SUBSURFACE WASTEWATER DISPOSAL SYSTEM APPLICATION

PROPERTY ADDRESS	
Town Or Plantation	Augusta
Street	255 Cony Street Ext.
PROPERTY OWNER'S NAME	
Divisor Lot #	
Last: Murphy	First: Mike
Applicant Name:	Mike Murphy
Mailing Address of Owner/Applicant (if Different)	255 Cony Street Ext. Augusta ME 04330

SUBSURFACE WASTEWATER DISPOSAL PLAN

REPLACEMENT SYSTEM VARIANCE REQUEST

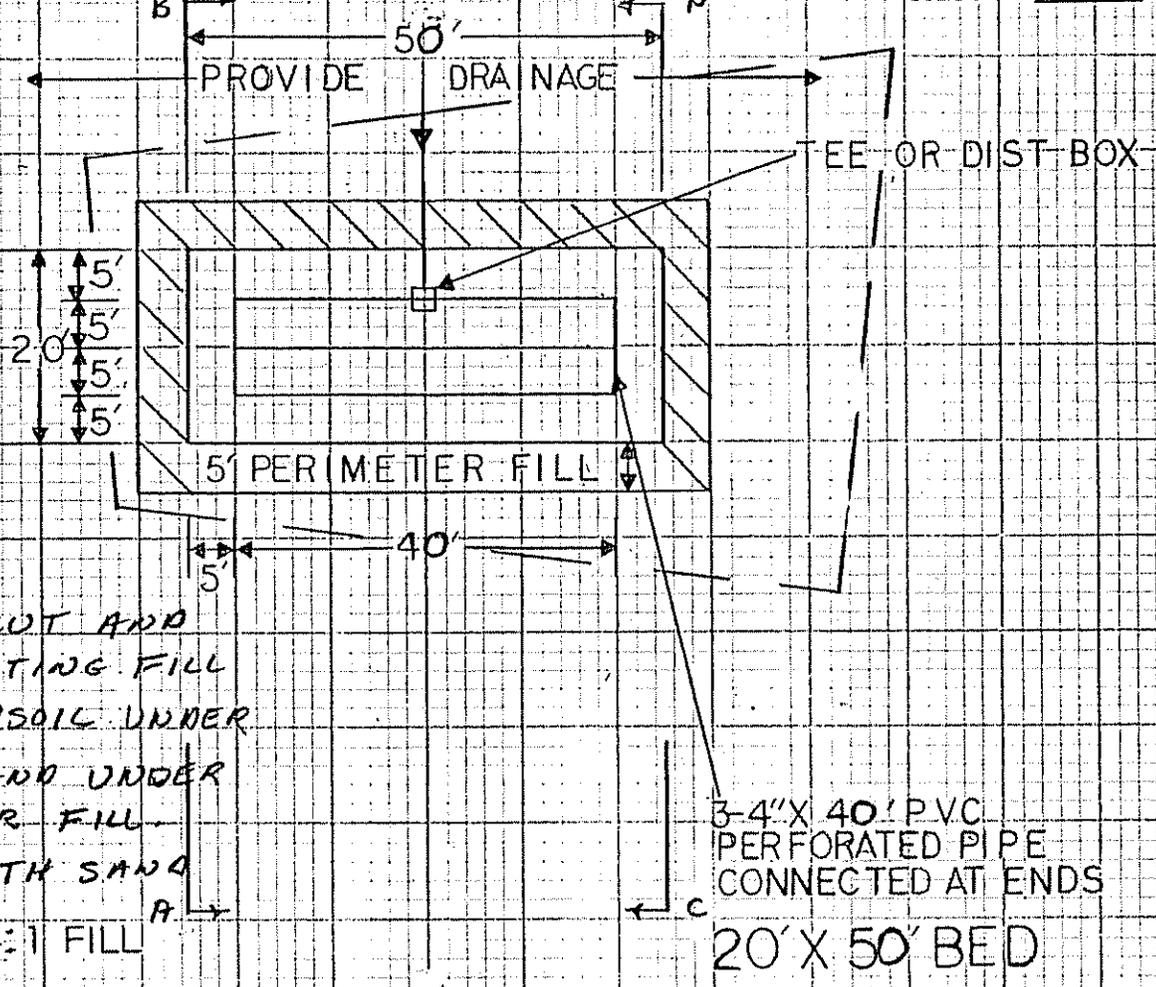
1. Fill extension Grade—to 3:1 AS NEEDED AT NORTH EAST CORNER.
2. _____
3. _____

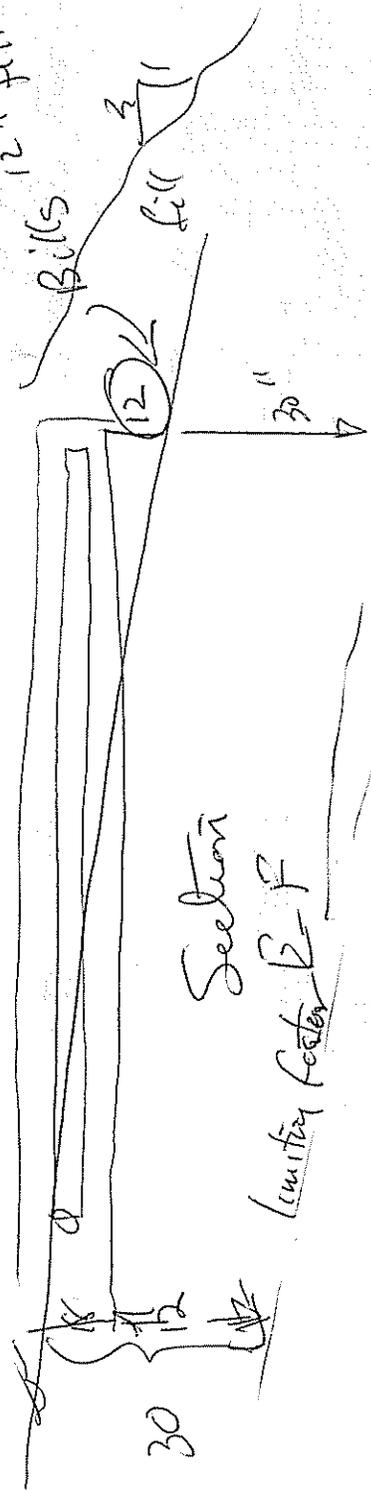
12" fill shown

See Section A-B & C-D

Not clear to Contractor unless he sees

Section E-F
